Federal Aviation
Administration

ZODIAC CH 601 XL AIRPLANE SPECIAL REVIEW TEAM REPORT JANUARY 2010

Figure 8: Zodiac Airspeed Calibration Evaluation per 14 CFR Part 23 § 23.1323(b)

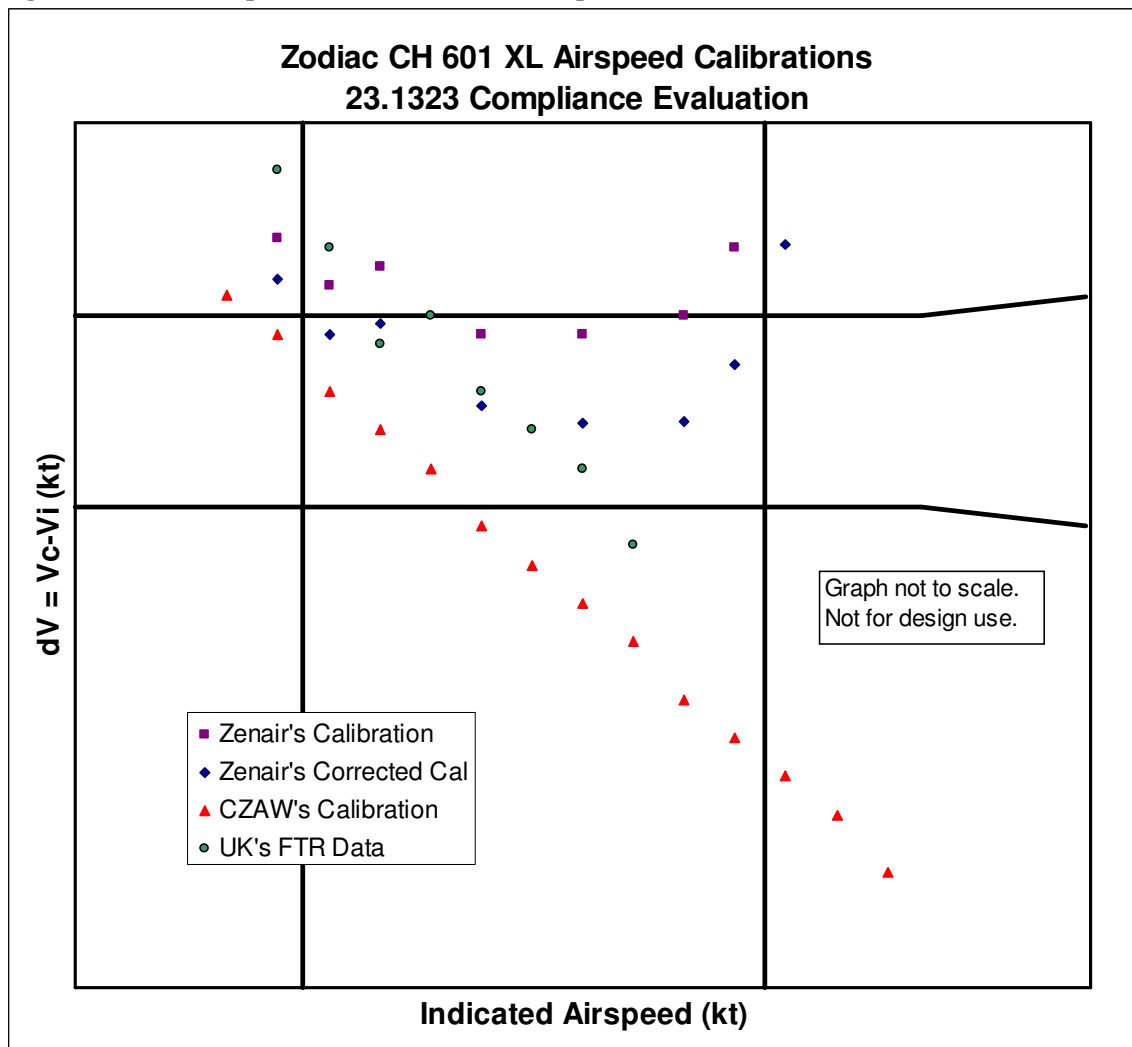
The UK LAA's flight test results are similar in magnitude to the manufacturer's data, but trend with CZAW's data making the comparison inconclusive. Using a different approach to determine the validity of the calibration data, a 14 CFR Part 23 § 23.1323(b) analysis was performed on these data sets and shown graphically in Figure 8. It should be

To evaluate the airspeed error per 14 CFR Part 23 § 23.1323(b), the error dV , must be less than ± 5 knots or 3% bounded by a lower airspeed of $1.3V_{S1}$ to a maximum airspeed of V_{NE} . Using the manufacturer's values, this means that to meet 14 CFR Part 23 § 23.1323(b), all the applicable data needs to fall in the enclosed ± 5 knot rectangle.

- 16) Proper airspeed calibration procedures (acceptable methods and associated corrections) should be added to ASTM guidance for ASTM F2279, or some other
